**CONSTRUCTION PLANS**  
**PLAN AND PROFILE OF PROPOSED**  
**BELFORD AVENUE BRIDGE AND HAPPY CANYON CREEK**  
**TOWN OF PARKER, COUNTY OF DOUGLAS, STATE OF COLORADO**

As Constructed	BELFORD-HAPPY CANYON CREEK TITLE SHEET			Project No./Code
No Revisions:	Designer:	DCS	Structure	
Revised:	Detailer:	DCS	Numbers	
Void:	Subset:	Title	Sheets:	T-1 of 1
				Sheet Number 1

As Constructed	BELFORD-HAPPY CANYON CREEK TRAIL DETAILS			Project No./Code
No Revisions:				
Revised:	Designer: DCS	Structure Numbers		
	Detailer: DCS			
Void:	Subset: Trail	Sheets: TD-1 of 3		Sheet Number 11

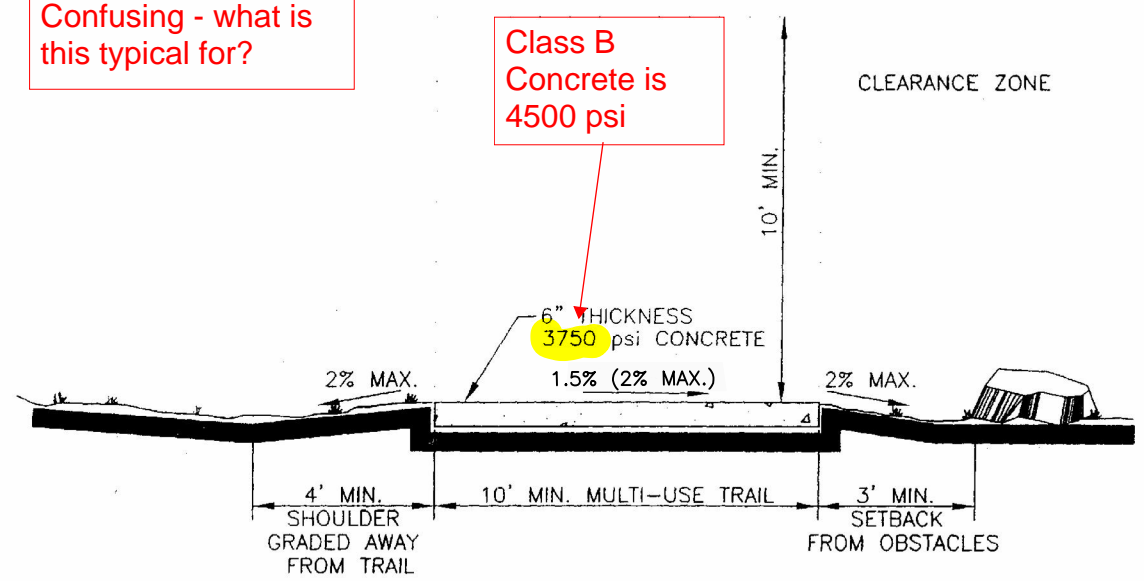
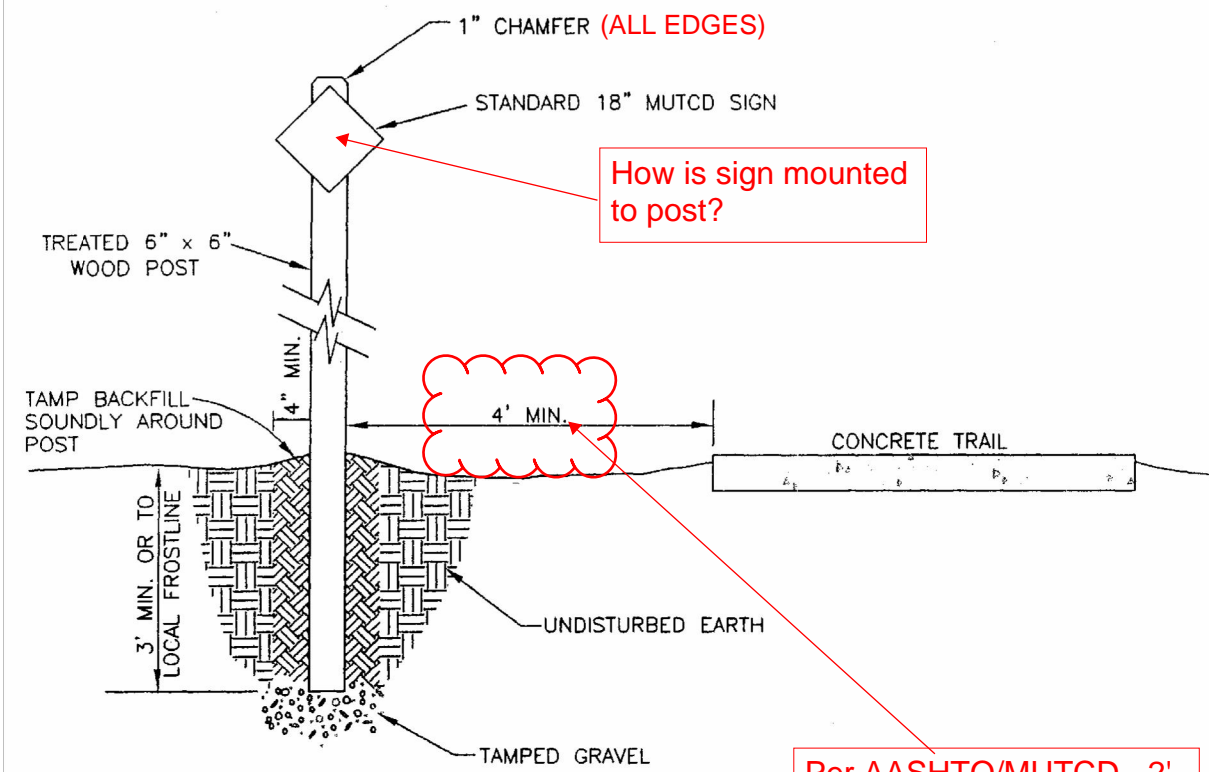
Confusing - what is this typical for?

Class B Concrete is 4500 psi

How is sign mounted to post?

Sign Detail?

As Constructed	BELFORD-HAPPY CANYON CREEK TRAIL DETAILS			Project No./Code
No Revisions:				
Revised:	Designer: DCS	Structure		
	Detailer: DCS	Numbers		
Void:	Subset: Trail	Sheets: TD-2 of 3		Sheet Number 12

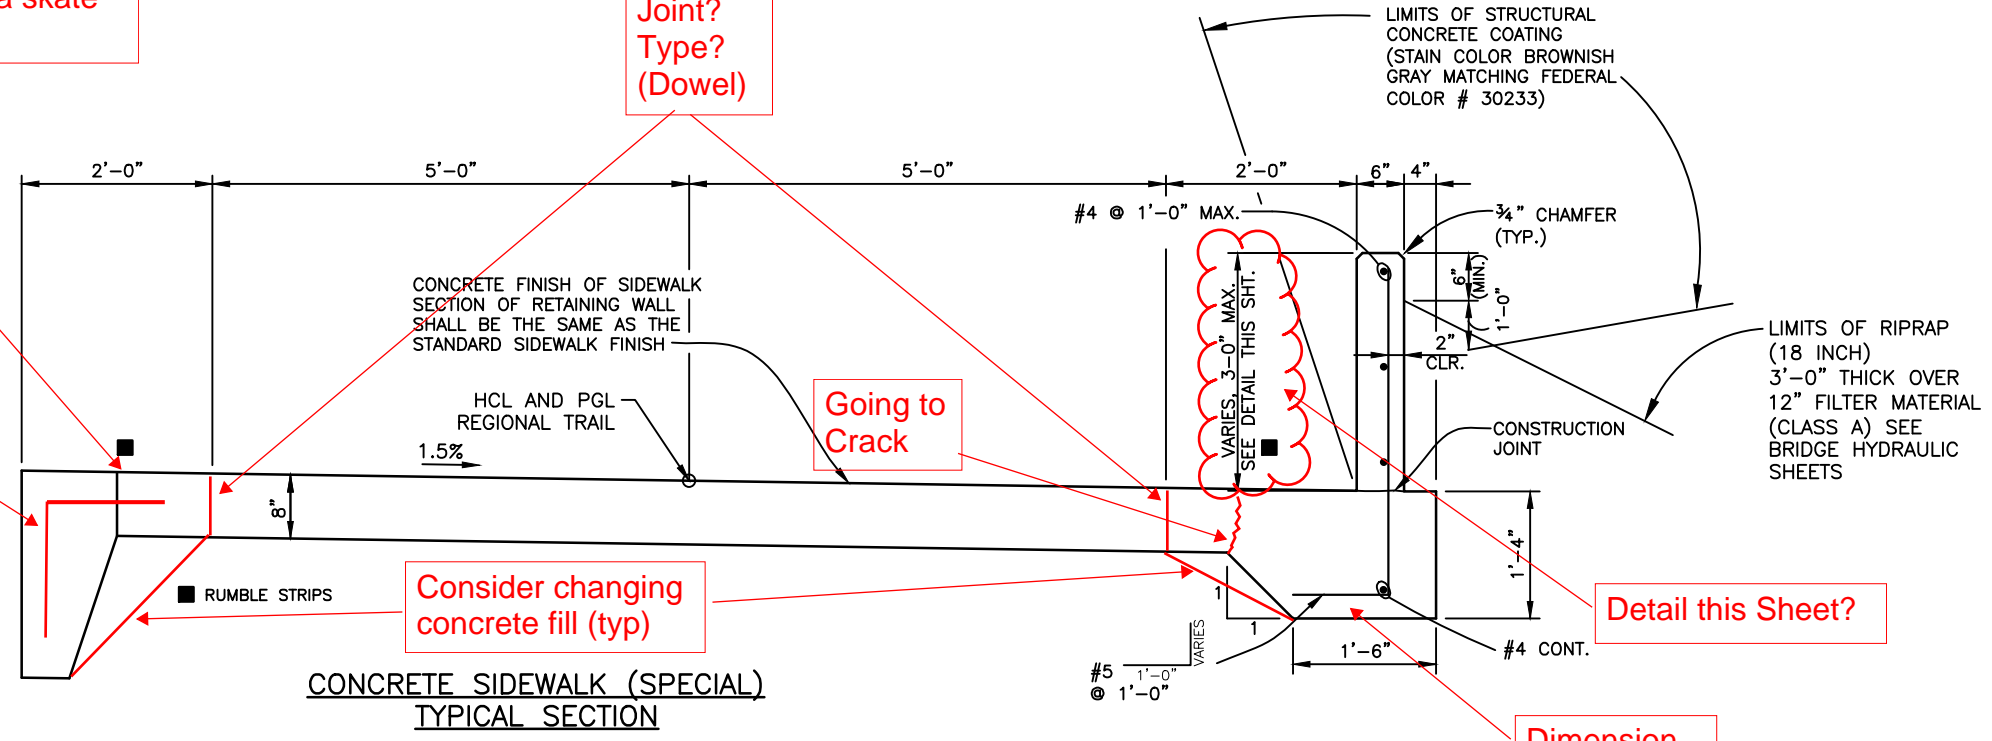
Rumble strip detail does not depict a longitudinal joint

Thickened Edge Detail? Rebar?

Joint? Type? (Dowel)

Detail this Sheet?

As Constructed	BELFORD-HAPPY CANYON CREEK CHEROKEE TRAIL PROFILE		Project No./Code
No Revisions:	Designer: DCS	Structure Numbers	
Revised:	Detailer: DCS		
Void:	Subset: Trail	Sheets: TP-4 of 12	Sheet Number 19

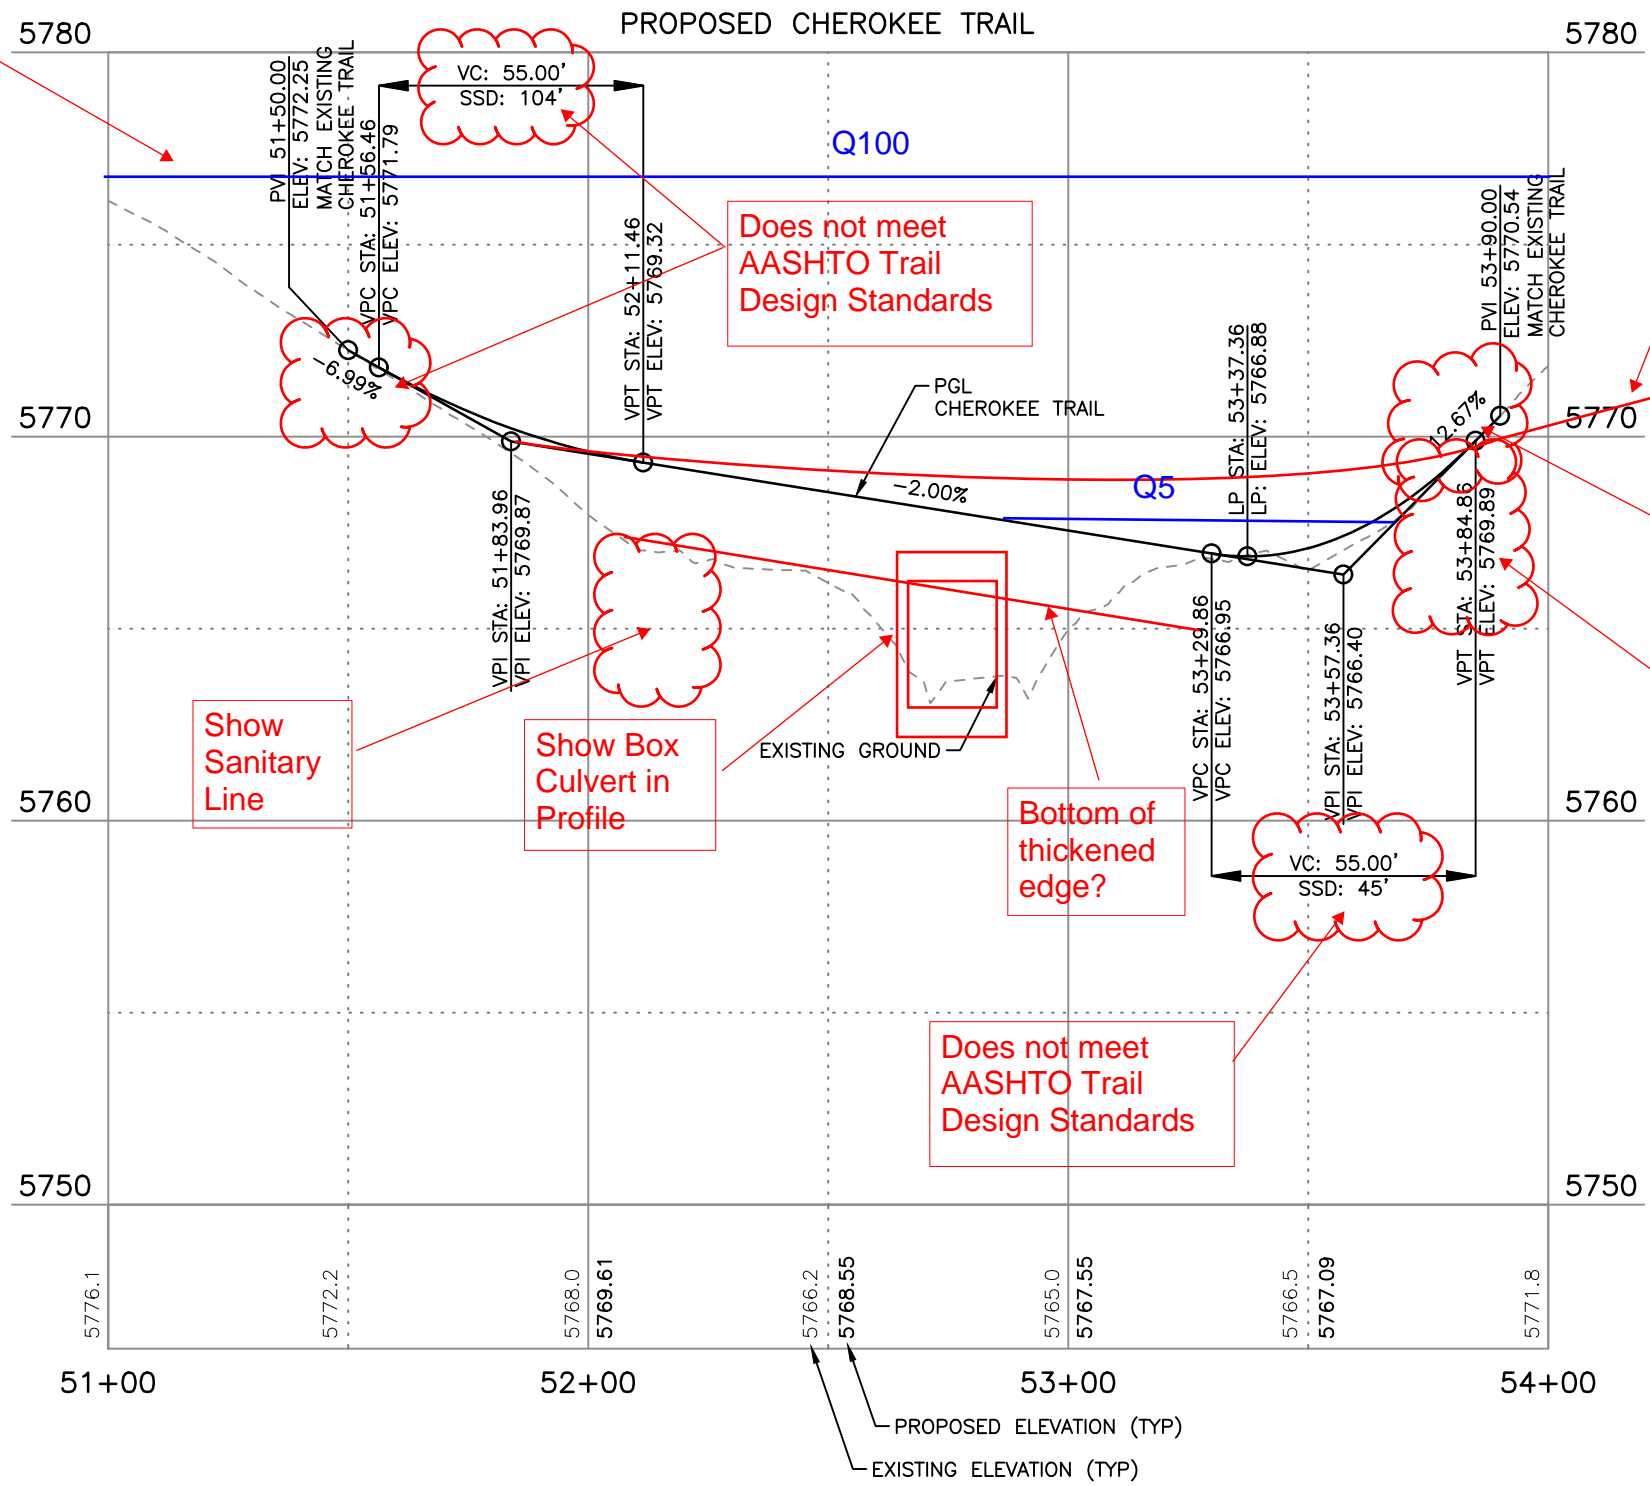
Provide Appropriate Signage to warn users that they are in a floodway and not to enter when water is present

Slope does not meet ADA, FHWA or AASHTO

Show Sanitary Line

Show Box Culvert in Profile

Show Proposed Storm Line

As Constructed	BELFORD-HAPPY CANYON CREEK MAINTENANCE ACCESS PLAN			Project No./Code
No Revisions:	Designer:	DCS	Structure	
Revised:	Detailer:	DCS	Numbers	
Void:	Subset:	Trail	Sheets:	TP-11 of 12
				Sheet Number 26

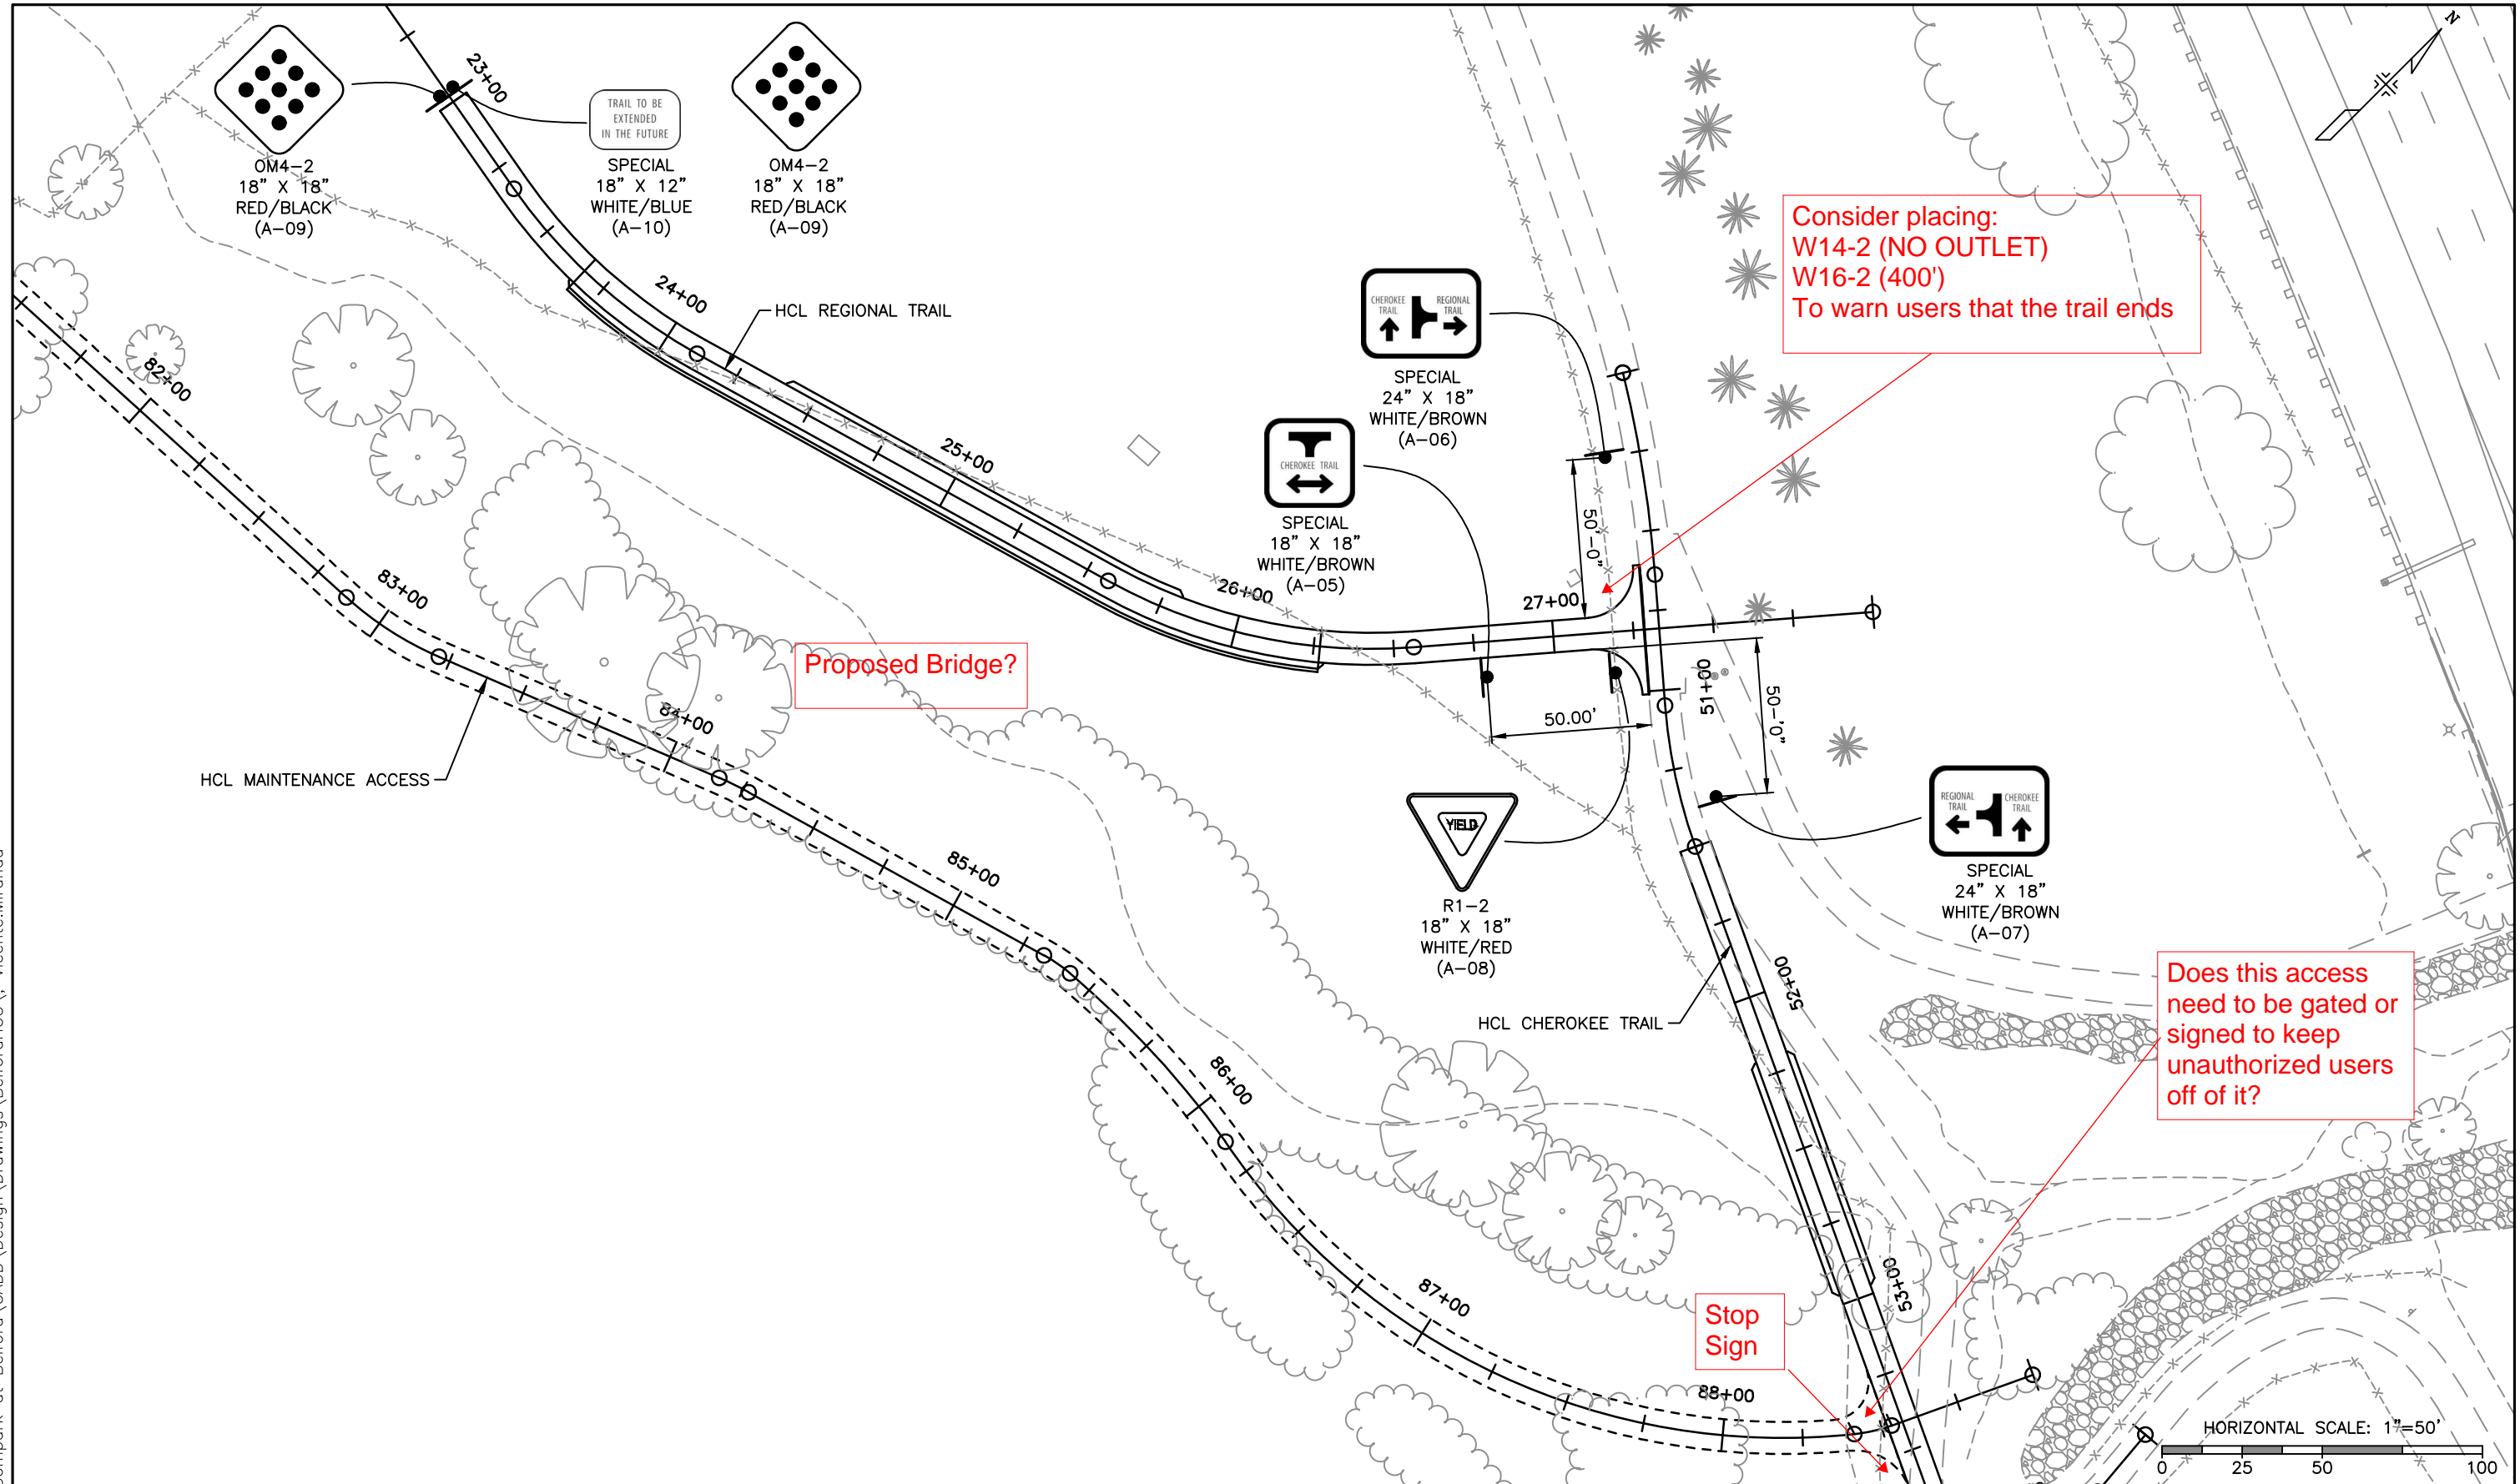
Consider placing:  
 W14-2 (NO OUTLET)  
 W16-2 (400')  
 To warn users that the trail ends
